**DEPARTMENT OF THE AIR FORCE**  
**AIR FORCE CIVIL ENGINEER CENTER**

Subject: Response to 22 June 2015 ADEQ Comments on  
WAFB - ADEQ Evaluation of USAF Response to ADEQ Comments  
Weekly Progress Report 27 April 2015 and Progress Report 4 May 2015  
Steam Enhanced Extraction - Site ST012  
Former Williams Air Force Base

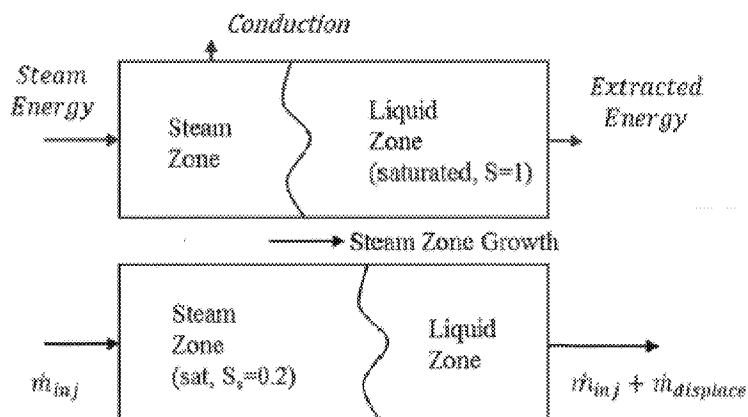
*Because the steam condenses, there is no reliable way to calculate or measure the actual steam volume in the formation.*

This is contradictory to the statement in the SEE Work Plan, Appendix D, p10,

"The injection of steam is a stable and predictable process. The steam propagation is governed by heat transfer to the formation, which has been studied intensively for oil recovery and has been applied to remediation applications for over 20 years."

A straightforward method to estimate steam zone volume and growth during injection is provided in the attached document, "Evaluation of Hydraulic Containment during Steam Enhanced Extraction." The method has been published in numerous references over the last 50 years (e.g., Marx & Langenheim, 1959; Mandl & Volek, 1969; Yortsos, 1982; Menegus & Udell, 1985). Application of the method to ST012 is also provided in the TEE Pilot Study Work Plan, Appendix C and in the TEE Pilot Study Evaluation Report, Appendix I. Use of the method as input to MODFLOW for assessing hydraulic containment is provided in the TEE Pilot Study Evaluation Report, Appendix H.

The Air Force (AF) agrees in principle with the reference and this reasoning. Empirical calculations can serve as a line of evidence in determining steam movement; however, the calculation is subject to the limitations of the data collection and inputs that were not specifically designed to support this type of detailed analysis. The effects of these limitations, which results in an overestimation of energy input when correlated to actual observed operational conditions, does not significantly contradict site conditions (subsurface temperatures and steam breakthrough to many wells in the LSZ and UWBZ). Based on operational data indicating steam breakthrough, the AF initiated depressurization in early June.
